**SANTA CLARA/SANTA CRUZ COUNTIES
AIRPORT/COMMUNITY ROUNDTABLE**

Subject: FAA Assistance with the SCSC Roundtable Questions Regarding the SUNNE Flight Procedure

Appendix A - Flight paths (current and proposed) and design decisions for SUNNE procedure

Flight paths for SFO 050, OAK 120 departures, and proposed SUNNE procedure

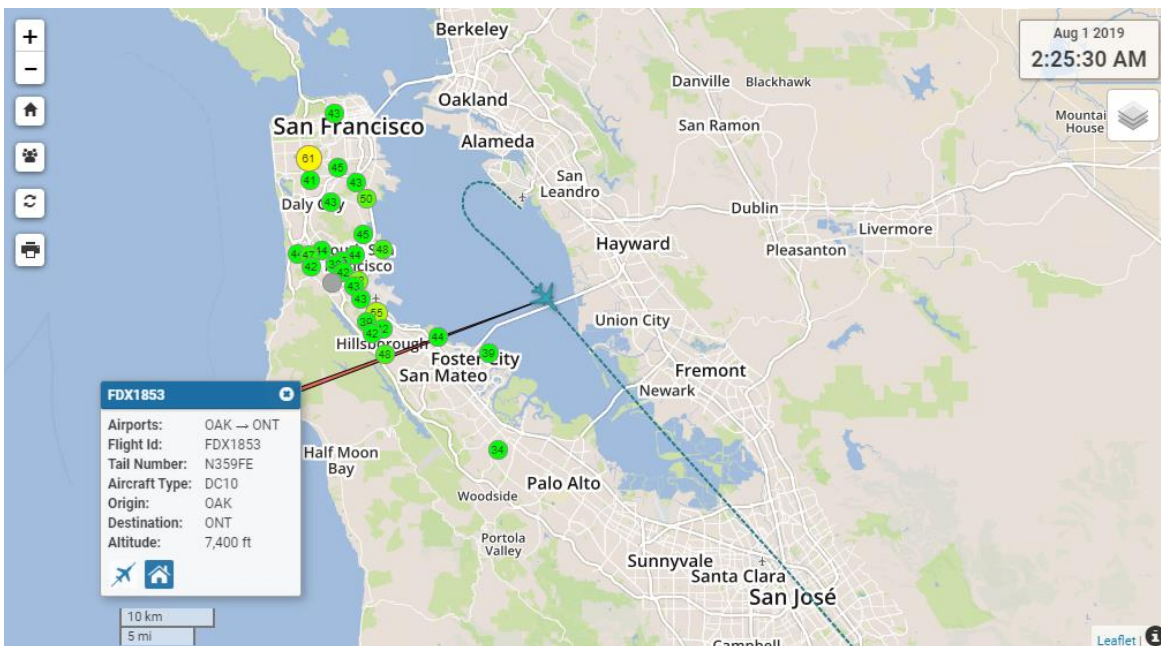
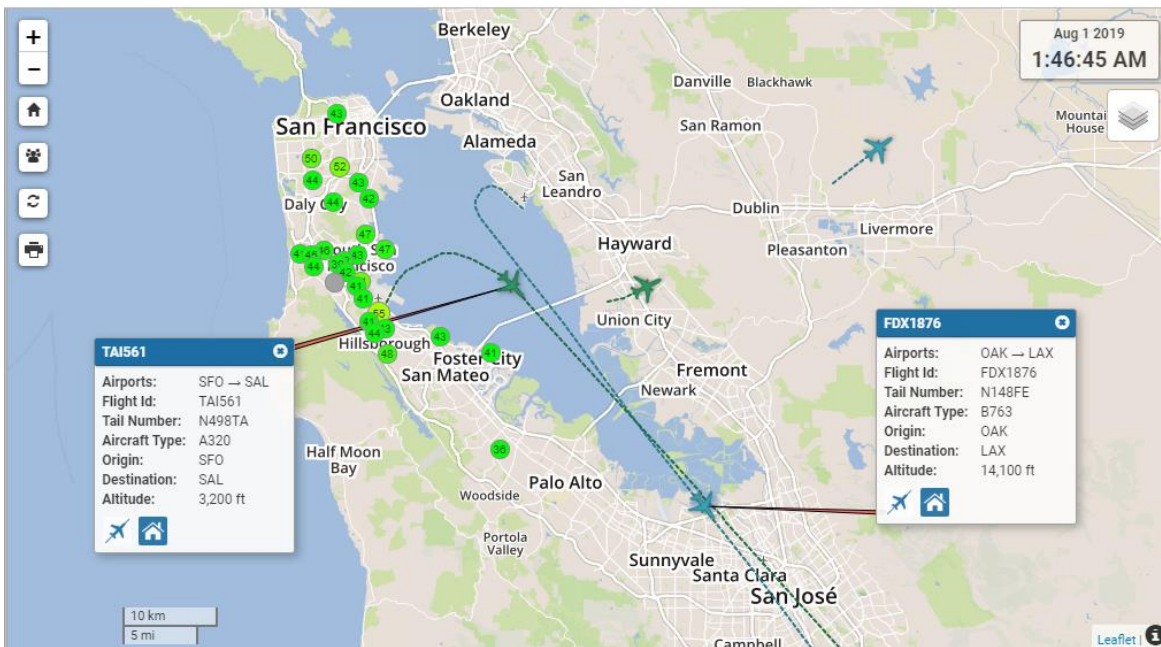
Ground tracks: If the goal is to reduce controller workload by creating a procedure, then why not design a procedure that follows the historical flight tracks as shown above? Why shift the ground tracks to new residential areas, which for many of them are already under noisy flight paths? The FAA acknowledged in the past that they should not have shifted the ground tracks of the BIG SUR without consulting with communities beforehand. Why do that again?

Altitudes and speeds: What are the proposed altitudes and speeds of the proposed SUNNE procedure at various radial distances from OAK (2 miles, 5 miles, 10 miles, 15 miles, 20 miles, 25 miles, 30 miles, 40 miles, 50 miles). How do these altitudes and speeds compare to the actual altitudes and speeds of the current radar-vectored flights at the same distances from OAK? Please provide a side-to-side comparison table of altitude and speed data for actual traffic and future traffic at the various radii from OAK. In addition, please specify expected horizontal distribution and compare it to historical OAK and SFO departures using conventional procedures based on at least 6 months of data.

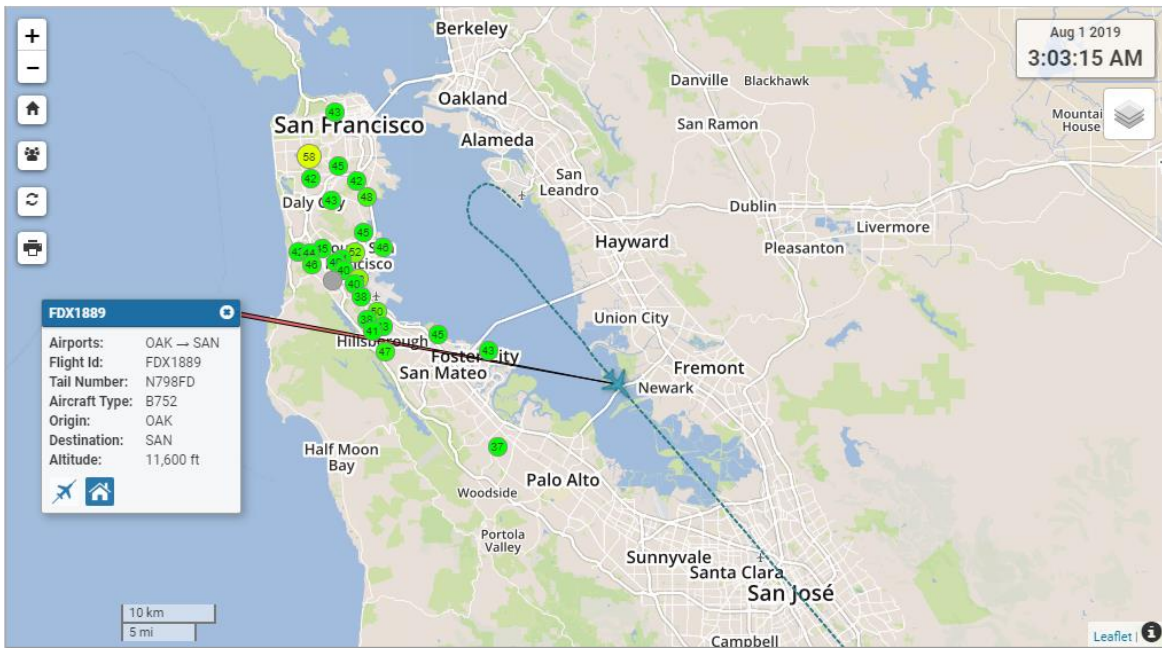
Waypoints: List all waypoints with their altitude and speed requirements of the SUNNE procedure. In addition, describe what happens after waypoint SUNNE (what other waypoints come after SUNNE? Do flights on the SUNNE procedure join another procedure later?)
